Reference: Water Quality Impact Assessment No.: 3276-WQ-004-3

Subject: Response Letter, Woodside Estates, Section 3, Lot 16A; 8747 Brook Road; Tax Map No.:

On behalf of the Applicant for the above-mentioned project, please find TNT Environmental, Inc. (TNT) responses for the requested information regarding the Water Quality Impact Assessment submitted May 24, 2020, and revised August 4, 2020:

## WATER QUALITY IMPACT ASSESSMENT 118-6-9 8747 BROOK ROAD FAIRFAX COUNTY, VIRGINIA

WATER QUALITY IMPACT ASSESSMENT MAP (REVISION DATE JANUARY 2021

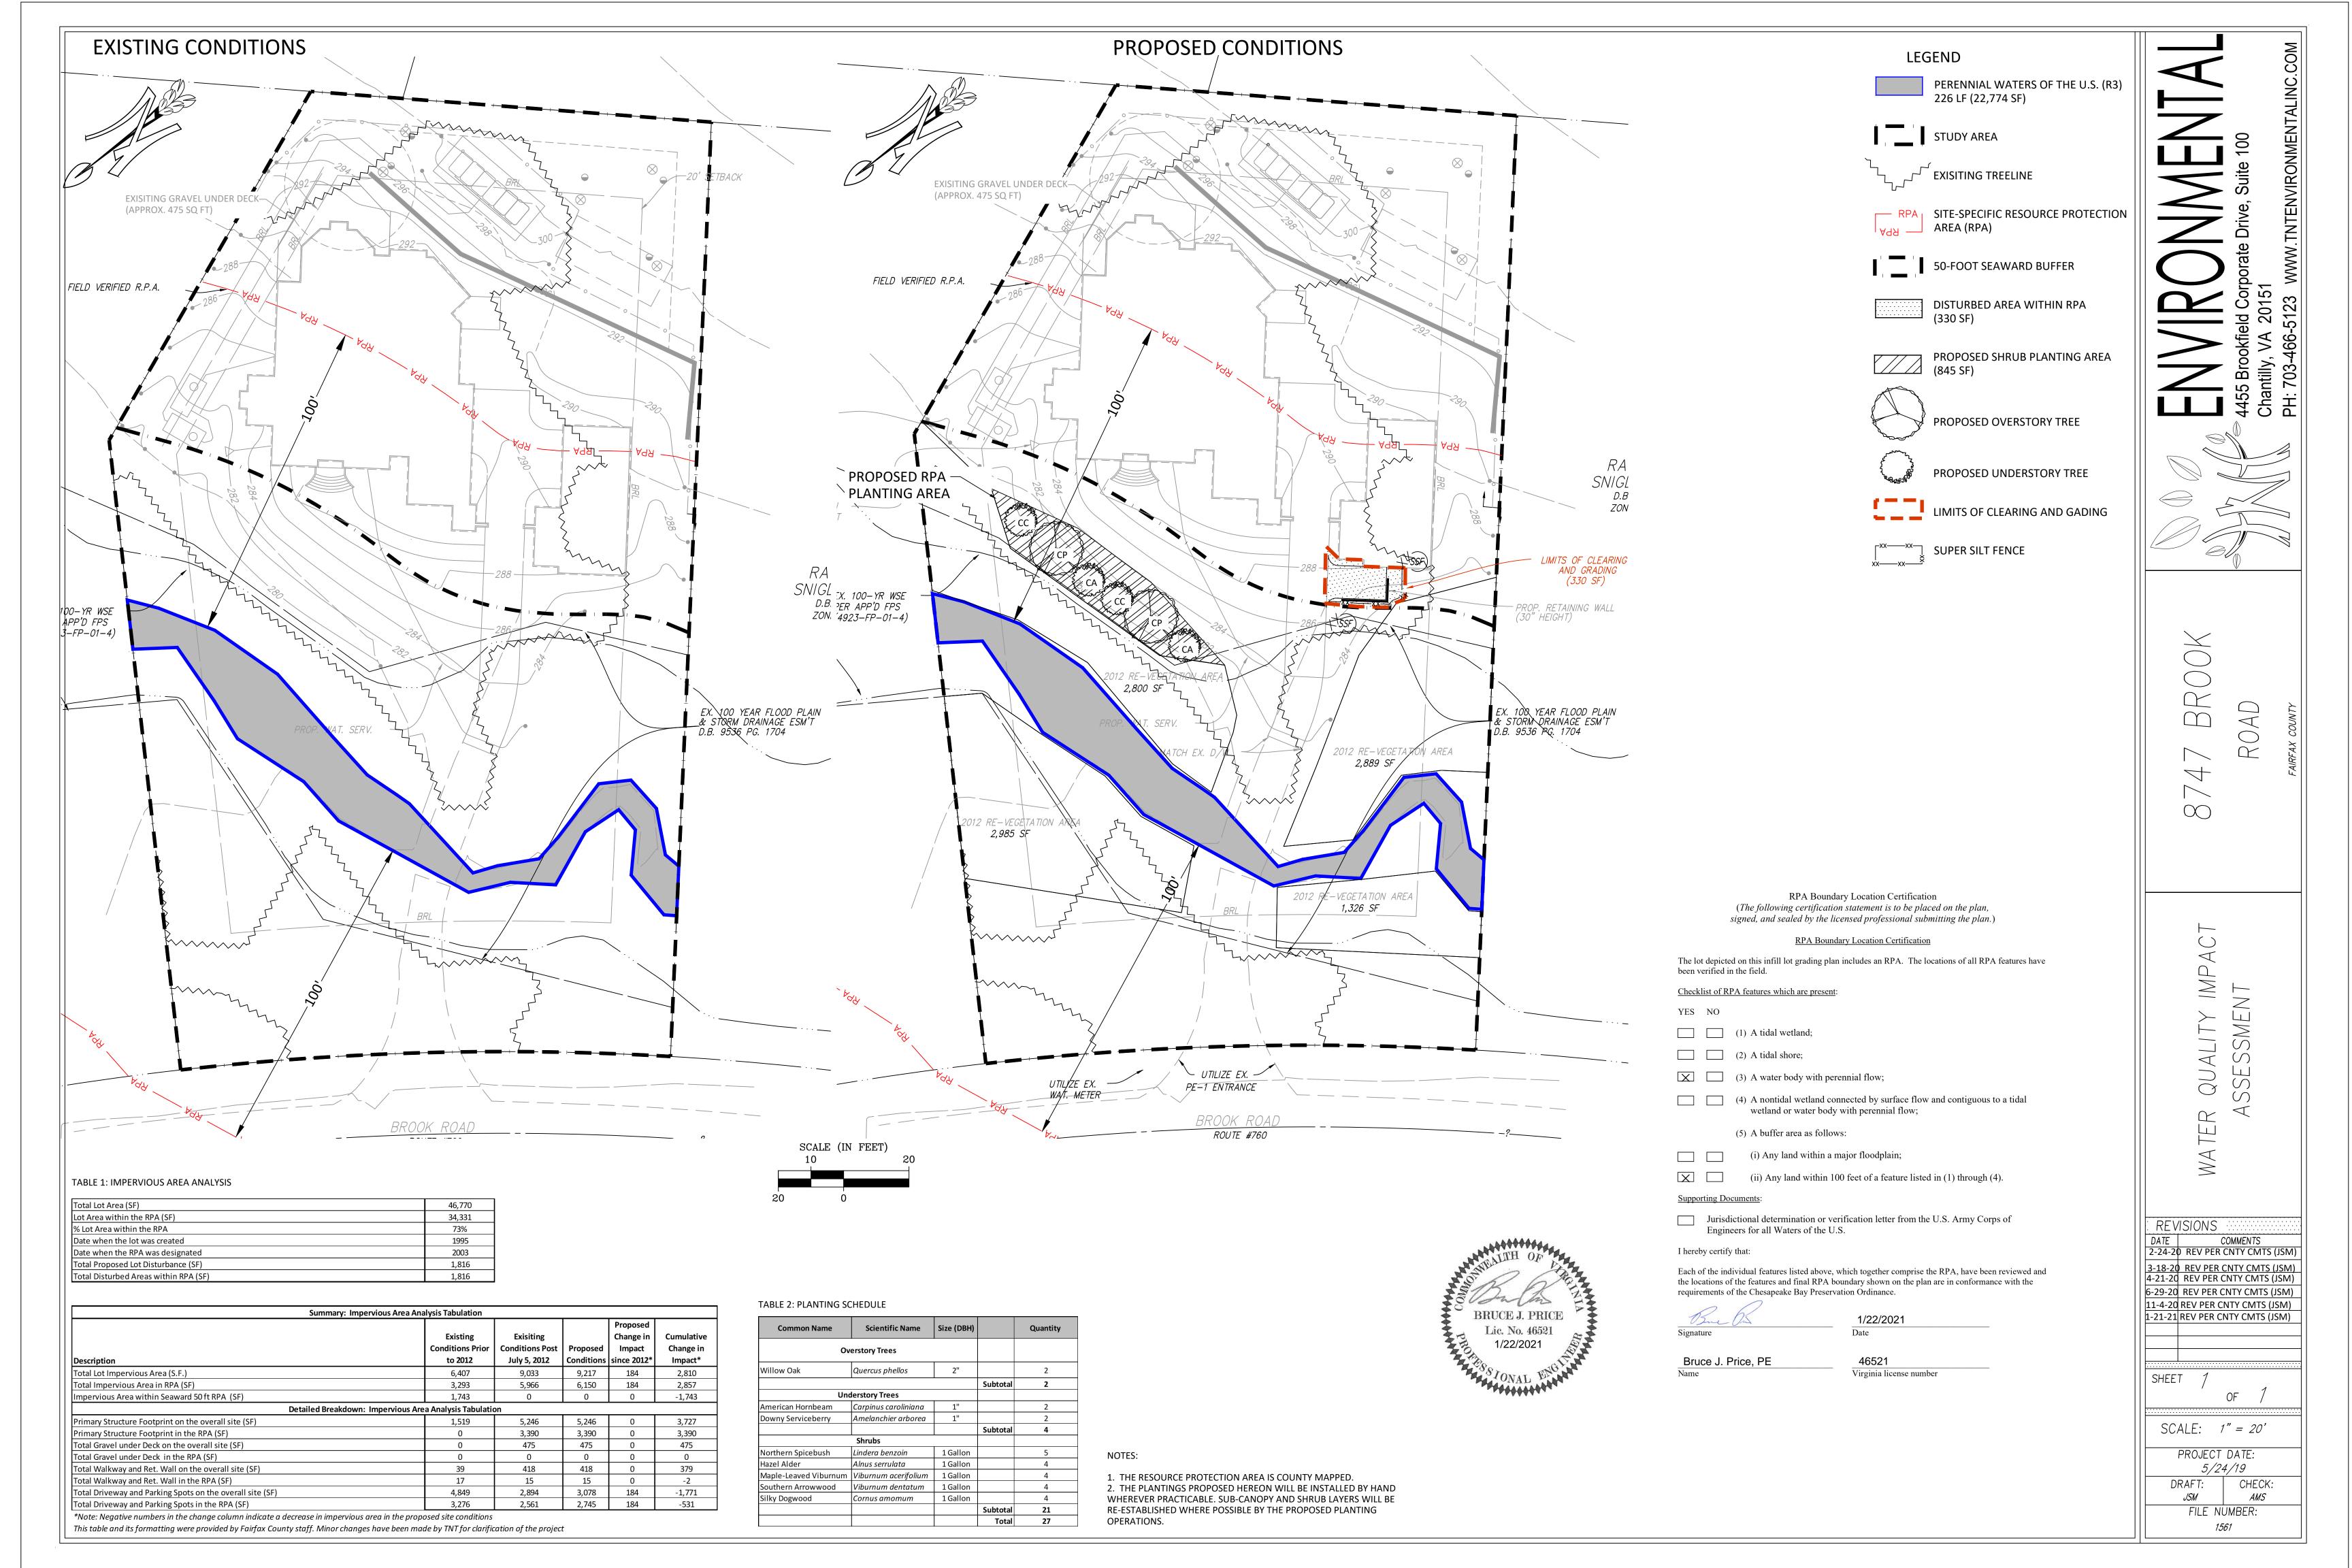
1. Water Quality Impact Assessment, Sheet 1

The existing conditions should match with the approved grading plan. If the existing conditions (as they are onsite today) do not match with the approved grading plan this should be explained in the WQIA. A sealed plat is required for the exception application under CBPO 118-6-9, the plan/plat submitted with the WQIA should match the plan submitted for the exception application.

Please ensure that the Plat / Plan Meets the requirements of ZO 9-011, paragraph 2, and includes the following:

- a) Separate existing condition and proposed condition plats.
- b) The existing condition plat shall show existing contours, existing impervious areas, turf areas and forested or tree cover areas.
- c) The proposed condition plat shall show proposed contours proposed land uses and impervious areas, field verified RPA, 50 feet seaward RPA, floodplain delineation and floodplain levels, proposed SWM facilities, utilities and easements, and sewage disposal system active and reserve locations
- d) setback, building block restriction lines
- e) Impervious area analysis existing versus proposed with breakdown of impervious areas within and outside RPA
- f) Limits of clearing and grading, Erosion and sediment control measures, tree save protection measures.

Response: The enclosed plan contains the items outlined above. Please note that no proposed contours are shown as the proposed improvements will be largely at grade.

## 5. Appendix VII.

Sheet 1 of 2, Lot 16A, Section 3 Woodside Estates. The RPA certification states that there is major floodplain on the lot. A correct RPA certification should be provided with the Plan/Plat.

## Response: Enclosed on WQIA plan
